# Product Change Notice

PCN Number: 16-0626-02  
Issue Date: 22-DECEMBER-2016

Exar Corporation

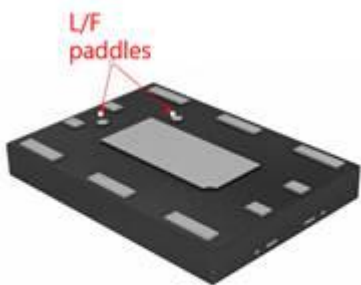
Change in Package 10L QFN lead dimensions, lead position from edge and delete L/F paddle.

| 10L QFN Package         | Change From:   | To:   |
| Lead dimension (L2)     | 0.65mm   | 1.1mm   |
| Lead Position from Edge | 0.16mm   | 0.1mm   |
| Leadframe paddle        | -  | Deleted   |
